ROLLIN RIDGE Filing No. 1 Grading & Erosion Control Plans El Paso County, Colorado

Remove Filing 1 and replace with
Pre-Development Grading & Erosion Control
Plans.

ROLLIN RIDGE ESTATES - FILING NO. 1

**GEC PLAN
TITLE SHEET**

DETENTION POND B
PLAN & DETAILS

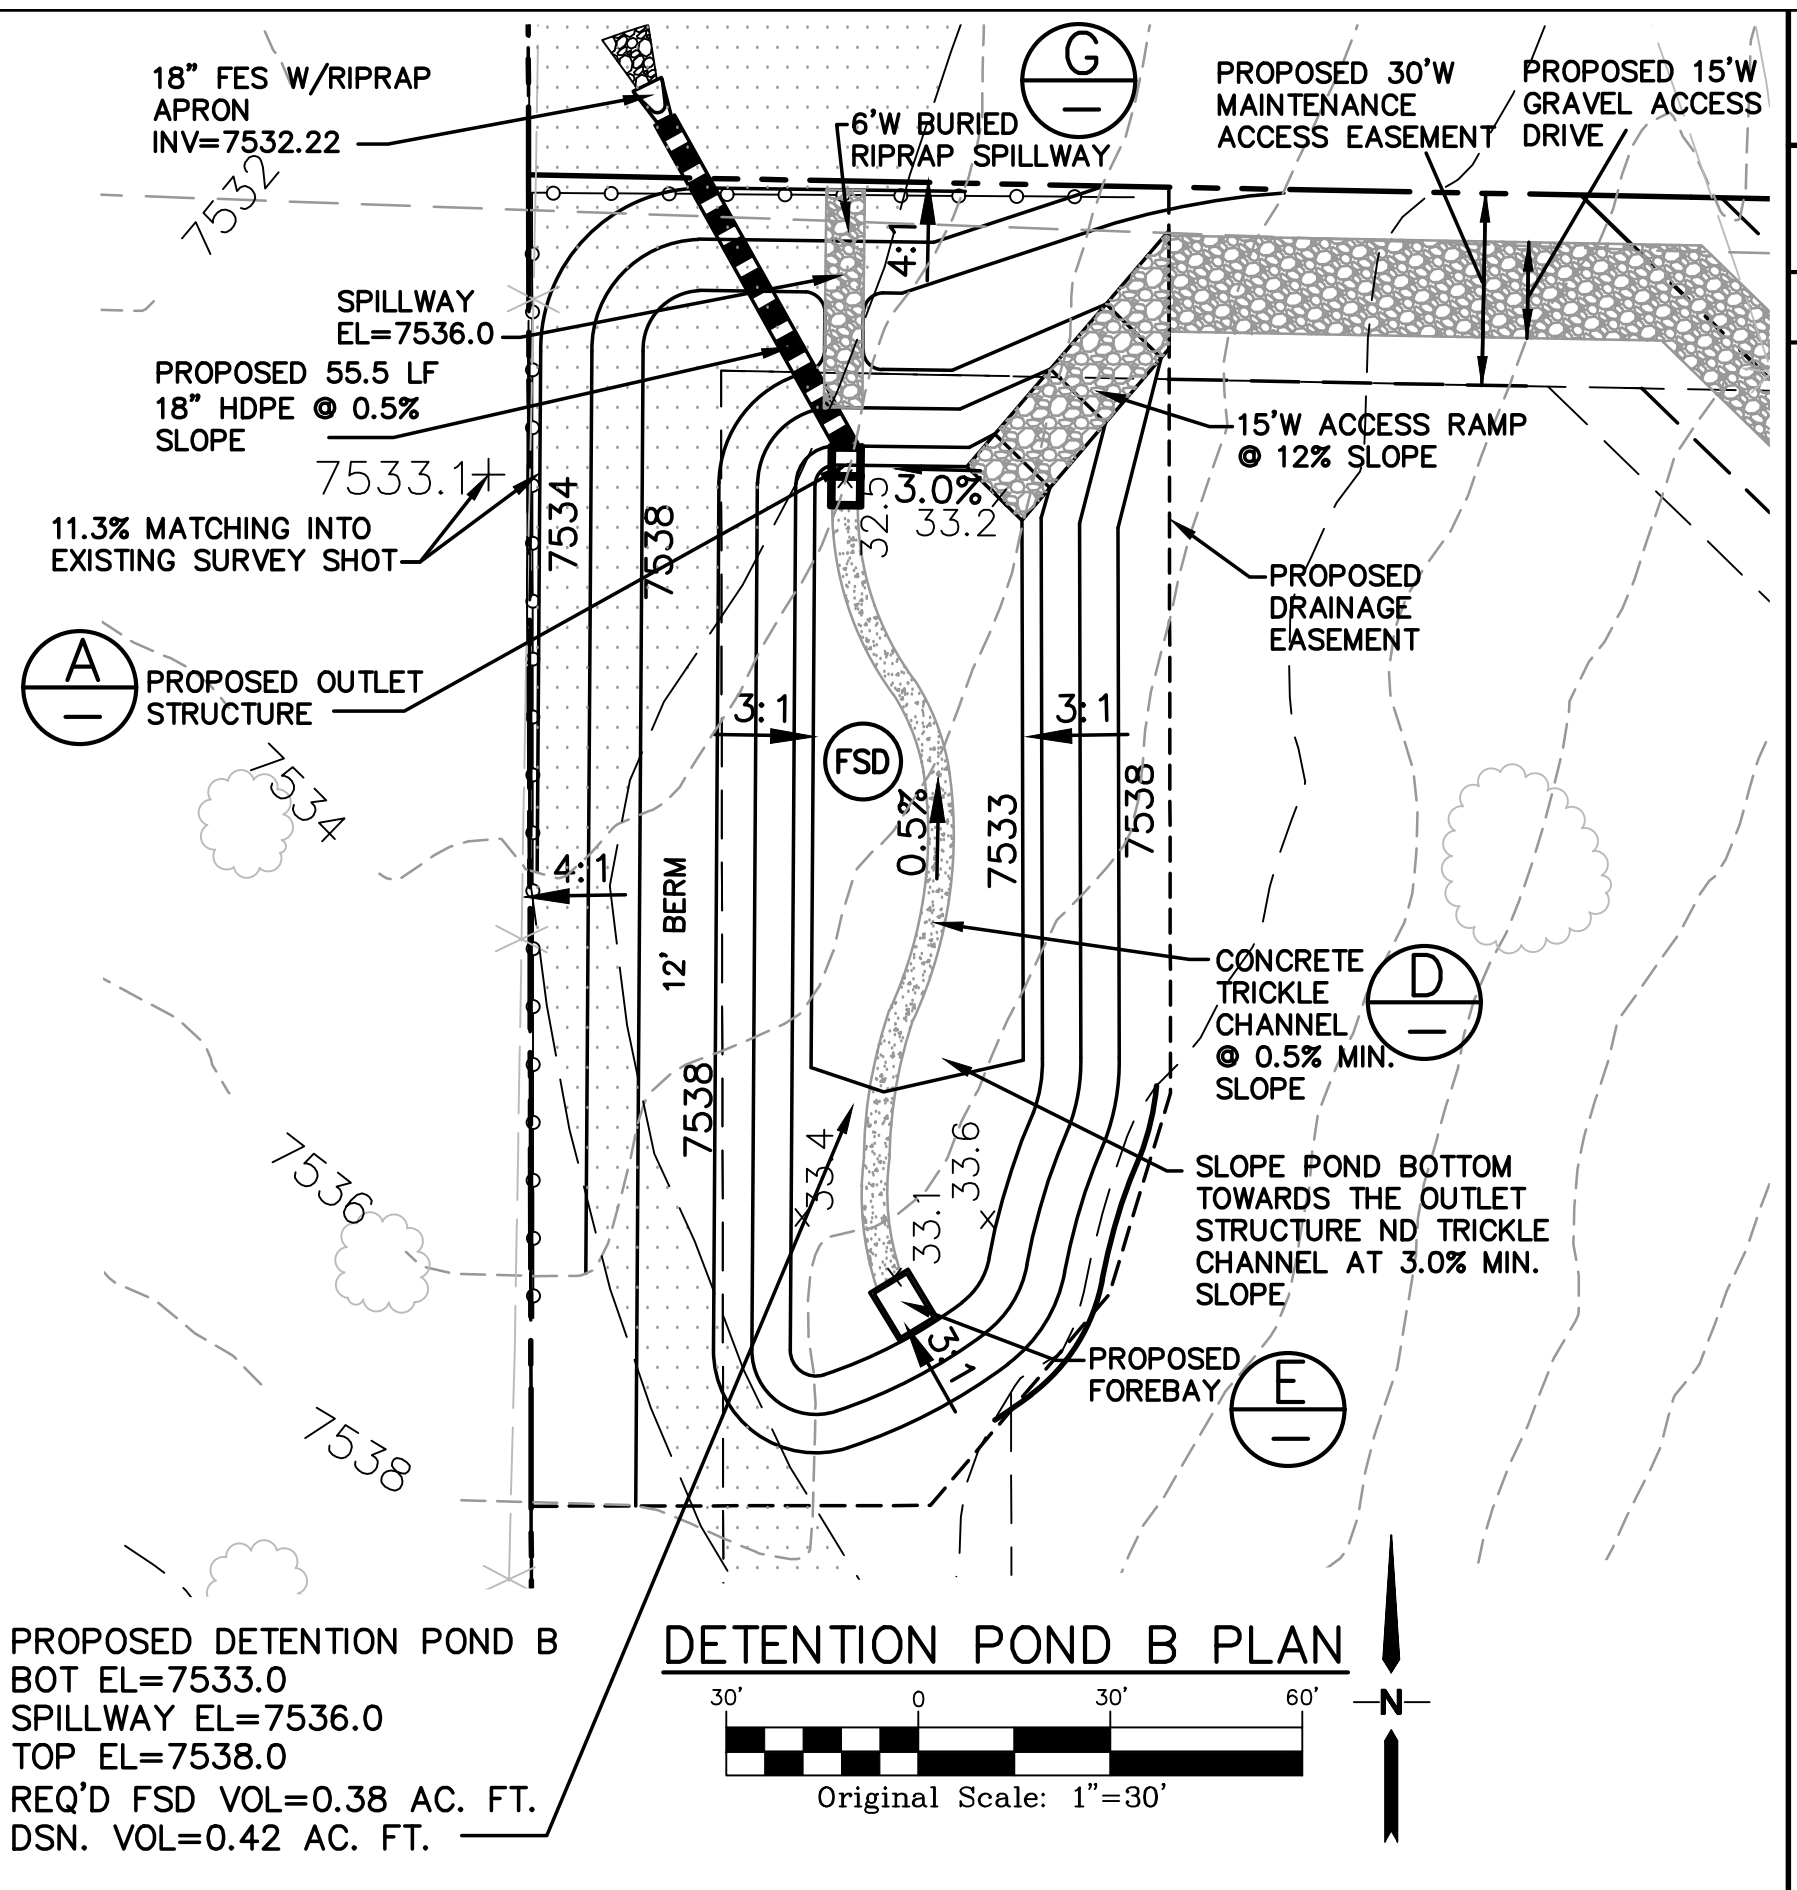
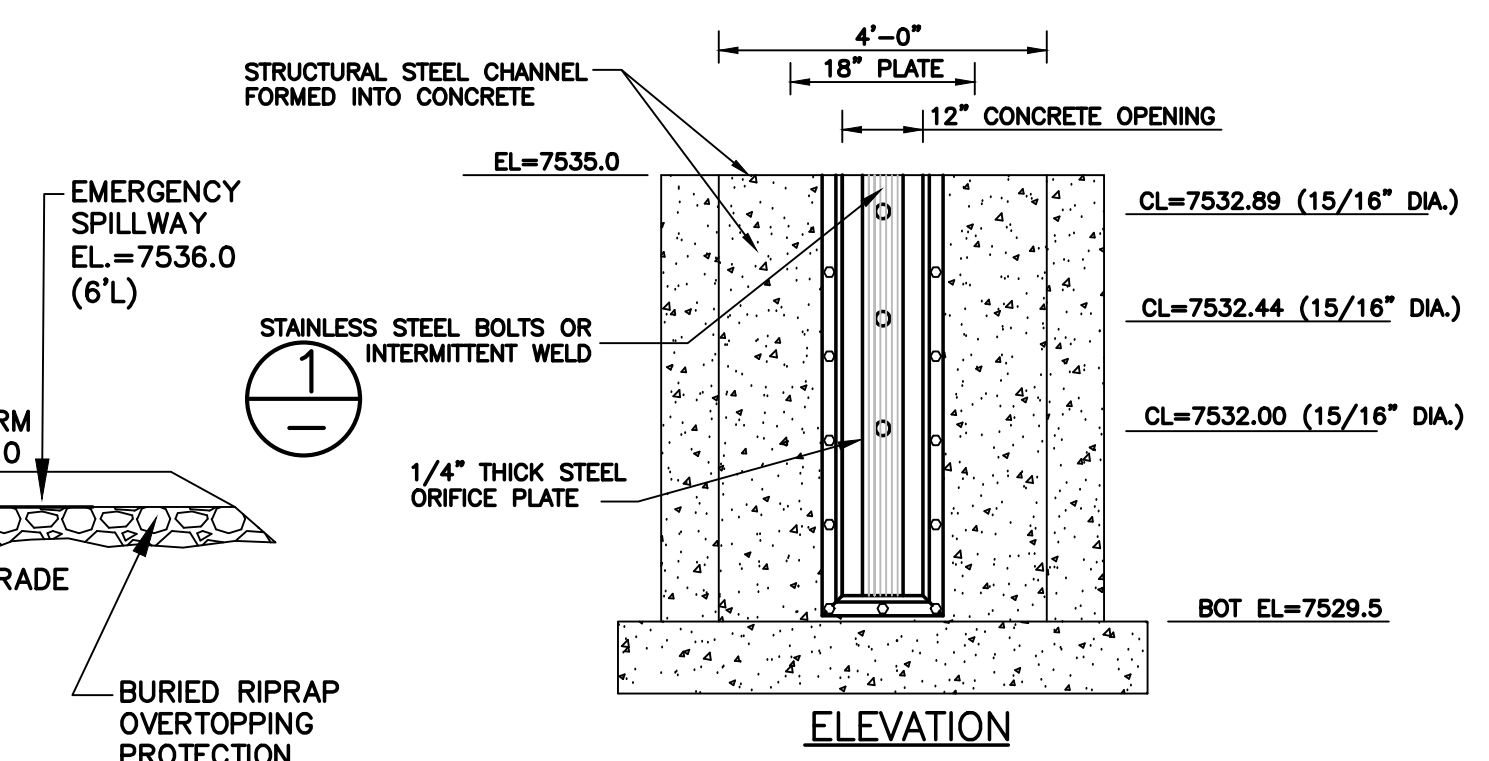
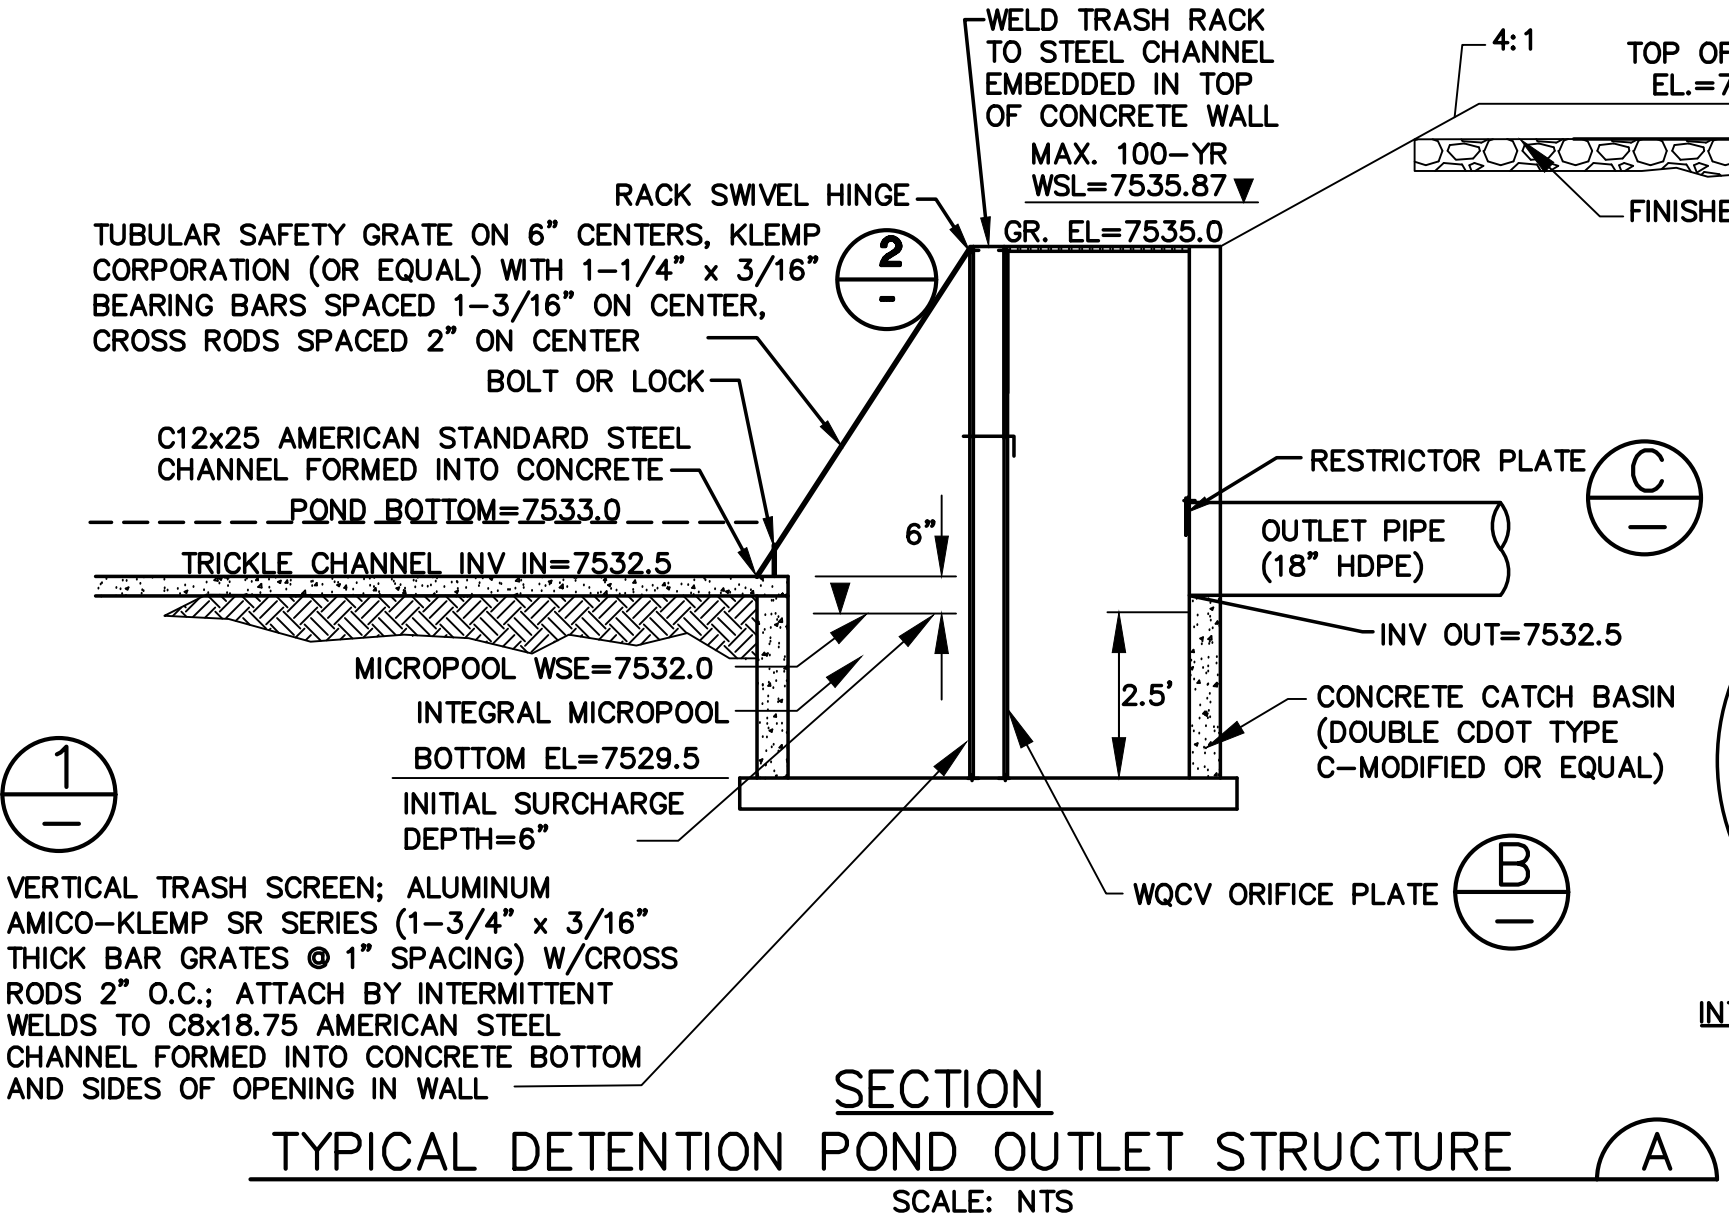
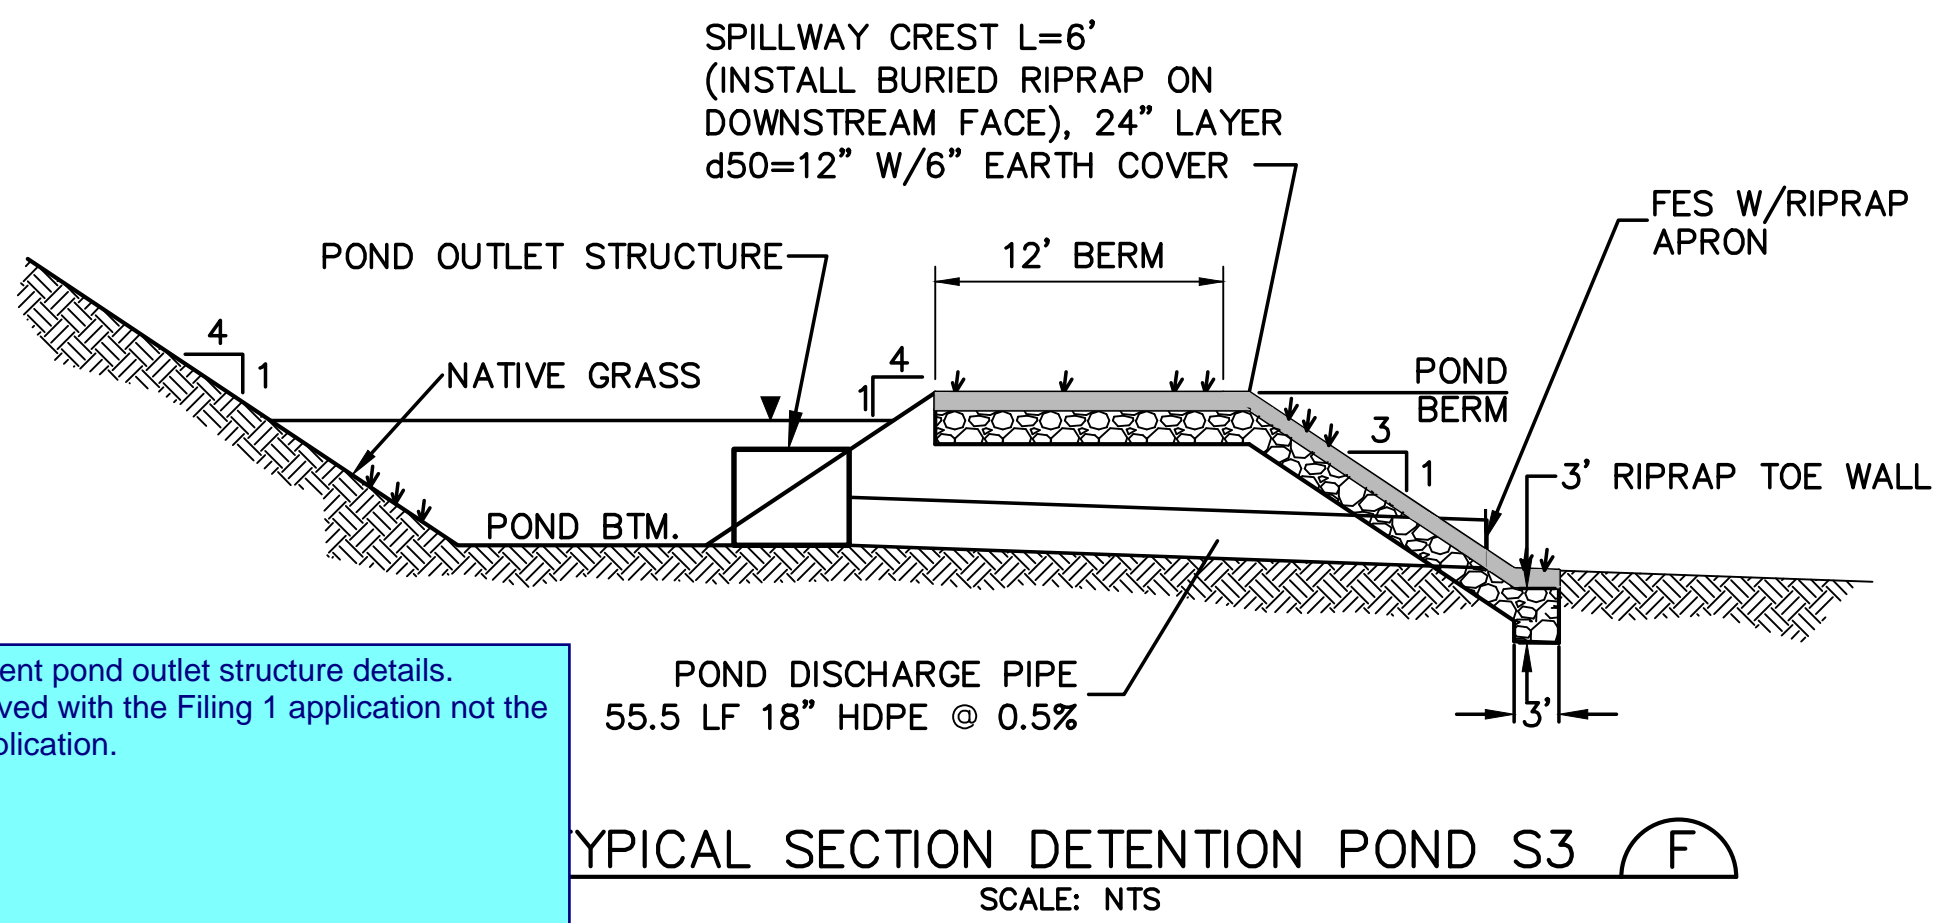
Remove permanent pond outlet structure details. These are approved with the Filing 1 application not the early grading application.
